# UNITED STATES PATENT AND TRADEMARK OFFICE

APPLICATION NO.	FILING DATE	FIRST NAMED INVENTOR	ATTORNEY DOCKET NO.	CONFIRMATION NO.
10/800,727	03/16/2004	Atsushi Hirota	118925	1036
25944	7590	05/03/2006	EXAMINER	
OLIFF & BERRIDGE, PLC P.O. BOX 19928 ALEXANDRIA, VA 22320			FIDLER, SHELBY LEE	
			ART UNIT	PAPER NUMBER
			2861

**Office Action Summary**

## DETAILED ACTION

Drawing A: Figure 5b from Sakaida et al. (US 6808254 B2), edited for clarity

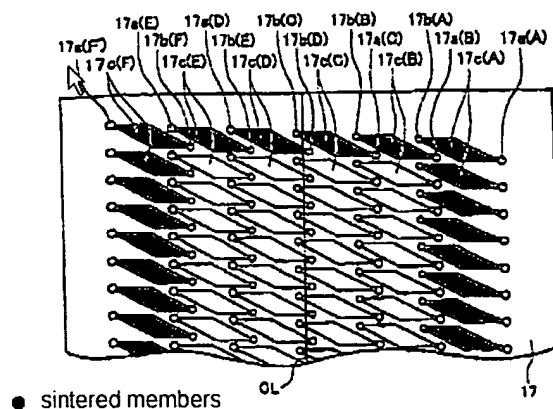
one or more sintered members that are, on the surface of the piezoelectric element provided with the plurality of individual electrodes, spaced from an outermost one of the individual electrodes with respect to an arrangement direction of the plurality of individual electrodes, in an outward direction from the plurality of individual electrodes (*outer electrodes corresponding to chambers 17c read as sintered members, Figure 5b; see Drawing A below*)

**\*regarding claim 5**, each of the individual electrodes, other than the outermost one with respect to the arrangement direction of the plurality of individual electrodes, is surrounded with corresponding ones of the individual electrodes arranged in a predetermined pattern (*individual electrodes corresponding to chambers 17c are surrounded with other like electrodes, Drawing A*); and wherein

the outermost one of the individual electrodes with respect to the arrangement direction of the plurality of individual electrodes is surrounded with a corresponding one of the individual electrodes and a corresponding one of the sintered members arranged in substantially the same pattern as the predetermined pattern (*any select sintered member is surrounded with both individual electrodes and other like sintered members, Drawing A*)

a plurality of sintered members that are, on the surface of the one of the plurality of piezoelectric elements, arranged adjacent to each other so as to surround the plurality of individual electrodes arranged adjacent to each other in a matrix (*sintered members surround the individual electrodes in a matrix, Drawing A*) the sintered members and the individual electrodes having substantially the same residual stress characteristics relative to the piezoelectric elements (*individual electrodes and sintered members are of the same construction, the only difference is location*); and
